APPENDIX L

# **Design Acceptance Workshop Comments and Response**

## City of Bend Review Comments

<b>Date:</b>	February 18, 2011	<b>Project Name:</b>	US97/Murphy Rd: Brookwood to Parrell
--------------	-------------------	----------------------	--------------------------------------

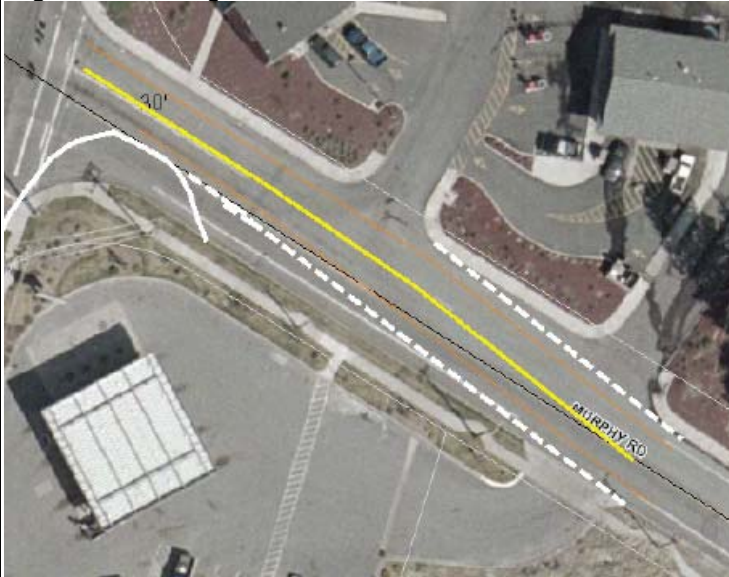
Item #	Dwg Sht/ Spec Paragraph	Comments	Type	Consultant Response
39	4	<p>Old Murphy – are we going to rename that street? Albertson's Way to get points from Albertson's owners?</p> <p>Old Murphy – the south side of old Murphy is the side of the street that has continuous curb without variation. The north side varies.</p> <p>Old Murphy is a 2-lane street. The proposal is to move the south side curb north with a large curb bulb-out extension. This causes a shift of 12' as the road moves from east to west – is the proposal to create the shift with paint? Not sure how to accomplish the shift as proposed. See next drawing showing the impact of the curb bulb-out extension on the roadway alignment with regard to this 12' shift:</p> <div style="text-align: center;">  </div> <p>As an alternative, I recommend moving the north side curb to the south to create the two-lane opening connection with 3<sup>rd</sup> Street. This results in a clean non-shifting roadway and</p>		Old Murphy approach redesigned – see final DAP plans

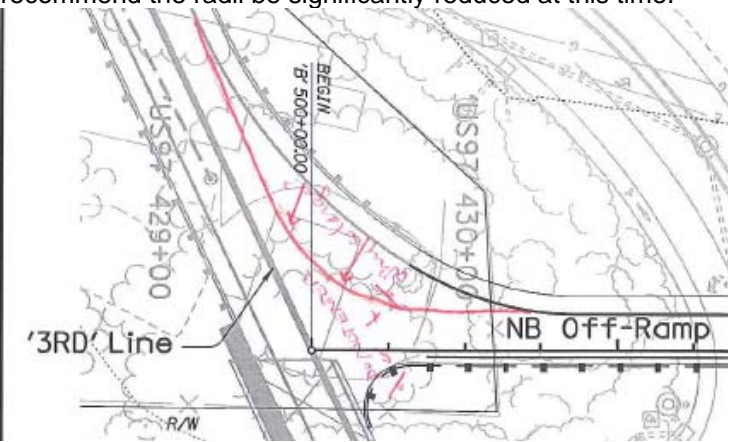
Item #	Dwg Sht/ Spec Paragraph	Comments	Type	Consultant Response
42	7	<p>There is a 600' gap in sidewalk on the project between the end sidewalk near Les Schwab and this new bridge sidewalk. As noted on page one of these comments – there may be a desire to create the connection and accommodate the continued sidewalk behind the guard rail proposed on the west side of 3<sup>rd</sup> Street. If not done now as part of the project, sidewalk connection beyond the south Les Schwab driveway to get through the guard rail will need to occur.</p> <p>If this 600 foot gap in sidewalk is mitigated – and the sidewalk on the west side of 3<sup>rd</sup> Street gets us all the way to the southbound on-ramp – should we then also connect to the new bike-ped trail system? Discuss with bike-ped subcommittee.</p>		Comments addressed at DAP workshop or during final design phase
43	7	<p>Guard Rail – there appears to be a gap in guard rail – the guard rail comes down the west side of 3<sup>rd</sup> Street, curb tight, which is the preferred location given the curbing, but then the guard rail appears to end and there is pedestrian rail on the back of the sidewalk. This gap is undesirable – motorists driving their cars northbound on the off ramp – could mistakenly continue straight – and then it is possible that the gap in guard rail would not protect them from continuing northbound and going over the edge. Another driver error could occur if a northbound ramp driver hits the intersection too fast and proceeds to attempt a left turn to the west – hitting the guardrail gap at a high angle – or because there is an elevation difference introduced by the curb, becoming launched and hitting the bridge railing too high and going over that way.</p> <p>I know this is a common practice in central Oregon on both City and ODOT facilities, but introducing the curb 6' from the rail is not a recommended safety practice in either the Roadside Design Guide or AASHTO's green book. AASHTO recommends a barrier-type bridge rail of adequate height should be installed <u>between</u> the pedestrian walkway and the roadway – and a pedestrian rail or screen should be provided on the outer edge of the walkway. This keeps the guard rail</p>		Comments addressed at DAP workshop or during final design phase

continuous and provides for guard rail in the preferred lateral location with respect to the curb.
